ADDENDUM NO. 2

TRANSPORTATION ENHANCEMENT DOWNTOWN STREETScape IMPROVEMENTS FOR THE CITY OF ASH GROVE, MISSOURI

PROJECT #STP-9900(826) H-R # 07-216 DATE March 26, 2013

INTERSECTION ELECTRICAL PLAN

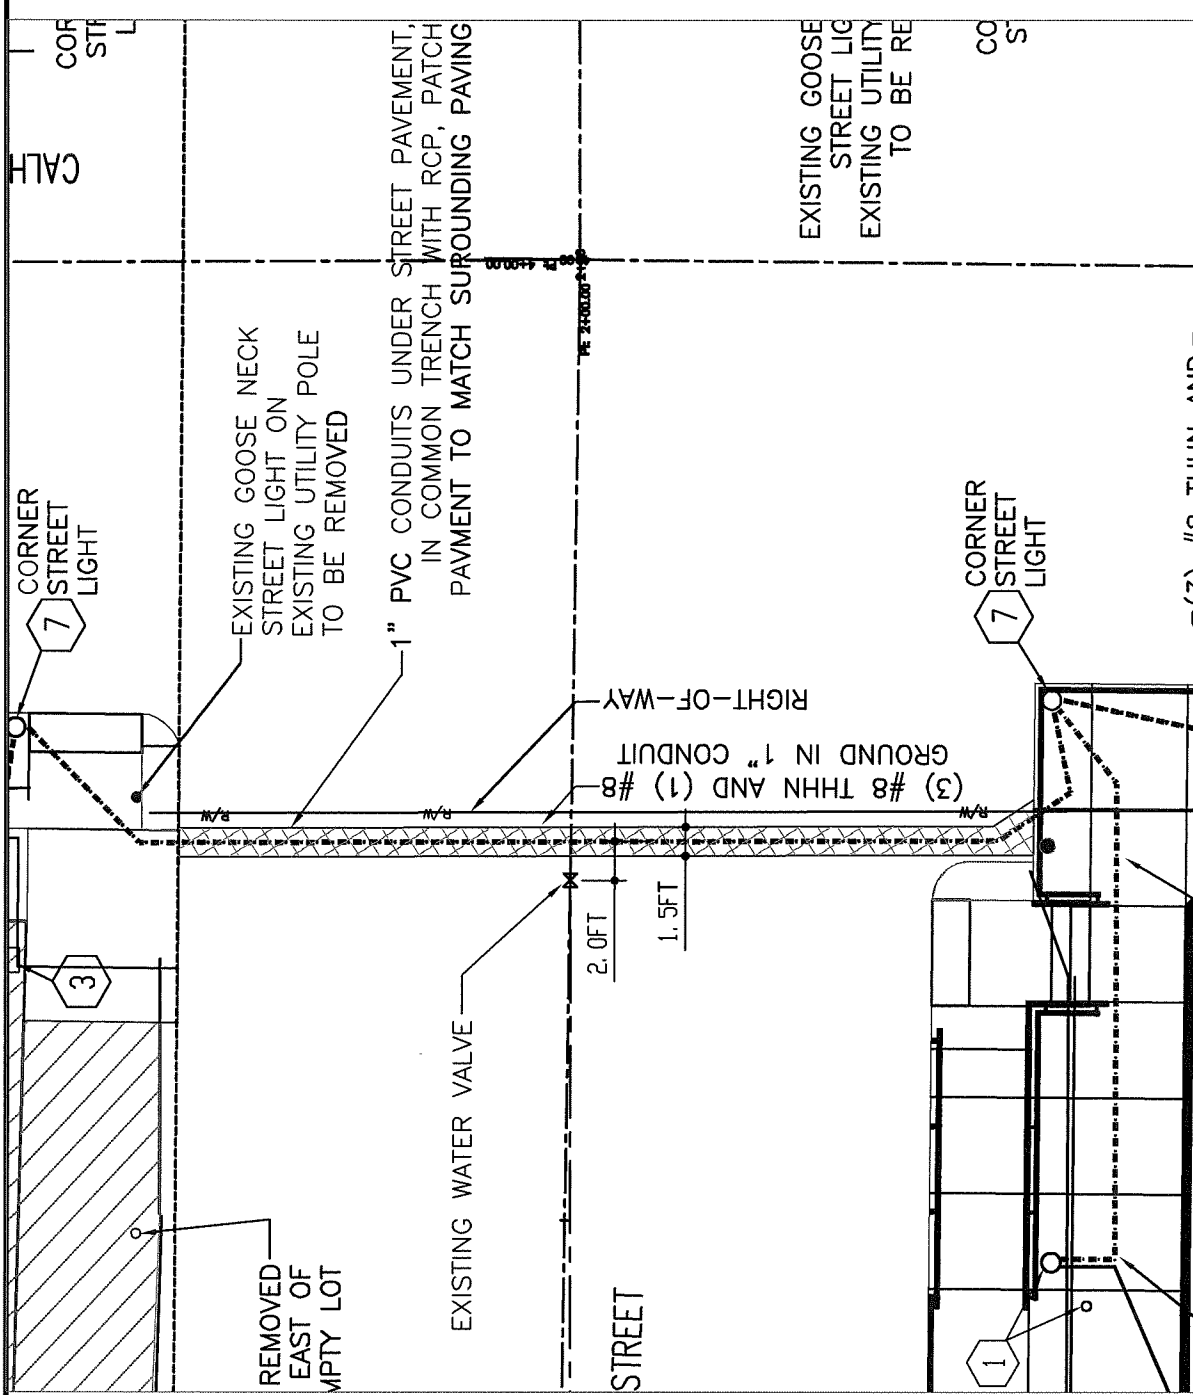
1. Plan Sheet C2.5, Detail #6, shall be modified regarding the depth of cover for the electrical conduits which are located on MoDOT right-of-way, which shall be 2'-6" rather than the 2'-0" shown.
2. Plan Sheet C1.6 indicates an electrical conduit run crossing Main Street, west of Rte F. The plan location shall be moved to approximately 32 ft west of the center line of Rte F onto City right-of-way. In the center of Main Street an 8" cast iron water main is located that is 27"± deep. The conduit depth shall be modified to provide a 6" clearance above the water main. See attached relocation drawing.

<div><p>HOOD-RICH, INC. ARCHITECTS AND ENGINEERS 801 SOUTH GLENSTONE AVENUE SPRINGFIELD, MISSOURI www.hoodrich.com</p></div>	<div><h1>DOWNTOWN STREETSCAPE IMPROVEMENTS</h1><p>for CITY OF ASH GROVE STP-9900(826)</p></div>			ORIG.	Site Plan.dwg
	<div><h2>REVISED LOCATION OF NEW CONDUIT TRENCH</h2><p>TO AVOID MO-DOT RIGHT-OF-WAY</p></div>			SCALE:	1" = 10'
				AS:	1 of 1
				DRAWING:	ADD # 2
			DATE:	March 26, 2013
